# Access Compliance Report

## Public Rights-of-Way

Intersection ID: 4810	Main Street: BEN_CRAIG_DR	Cross Street: MALLARD_CREEK_RD	Location:	N
ADA ID: 9842802DD9B9	Ramp Type: Perp	Initial Pass/Fail: Fail	Overall Compliance: No	Severity Score: 22.5
Codes/Mitigation Info/Possible Solution		Field Measurements/Component Compliance

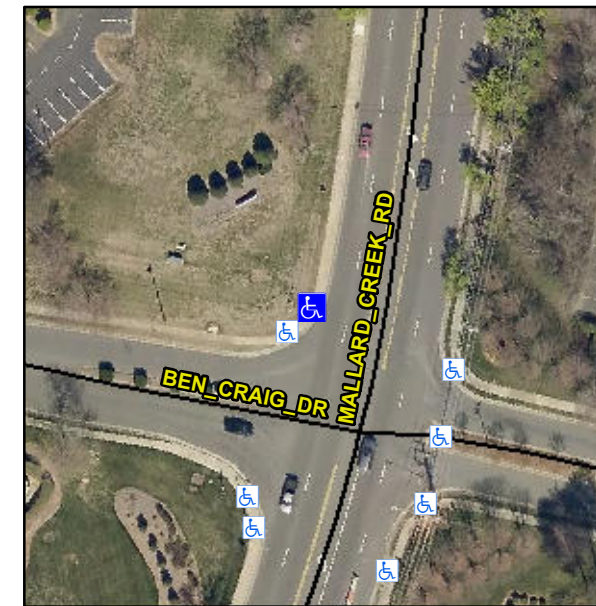
**Not Found, R304.5.1, R304.2.2**

Compliance	Description	Data	Compliance	Description	Data
N/A	Ramp Length (in)	61.0	No	Ramp Slope (%)	9.6
No	Ramp Width (in)	41.0	Yes	Ramp XSlope (%)	2.3
N/A	Flare Type LT	N/A	N/A	Flare Type RT	N/A
N/A	Flare Slope LT (%)	N/A	N/A	Flare Slope RT (%)	N/A
N/A	Flare Traversable LT?	N/A	N/A	Flare Traversable RT?	N/A
N/A	Landing Length (in)	N/A	N/A	DWS Provided?	N/A
N/A	Landing Width (in)	N/A	N/A	DWS Contrast?	N/A
N/A	Landing Slope (%)	N/A	N/A	DWS Length (in)	N/A
N/A	Landing X Slope (%)	N/A	N/A	DWS Full Width?	N/A
N/A	Landing Curb? (Y/N)	N/A	N/A	DWS Offset (in)	N/A
N/A	Shared Landing?	N/A			
N/A	Gutter Ponding?	N/A	N/A	Gutter Slope (%)	N/A
N/A	Gutter Lip Ht (in)	N/A	N/A	Gutter X Slope (%)	N/A
N/A	Painted X Walk1?	No	N/A	Painted X Walk2?	N/A
	X Walk 1 Direction	To SE		X Walk 2 Direction	N/A
N/A	X Walk 1 Width (in)	N/A	N/A	X Walk 2 Width (in)	N/A
	X Walk 1 Slope (%)	4.5		X Walk 2 Slope (%)	N/A
	X Walk 1 X Slope (%)	4.4		X Walk 2 X Slope (%)	N/A

**Remove & Replace Entire Ramp.**
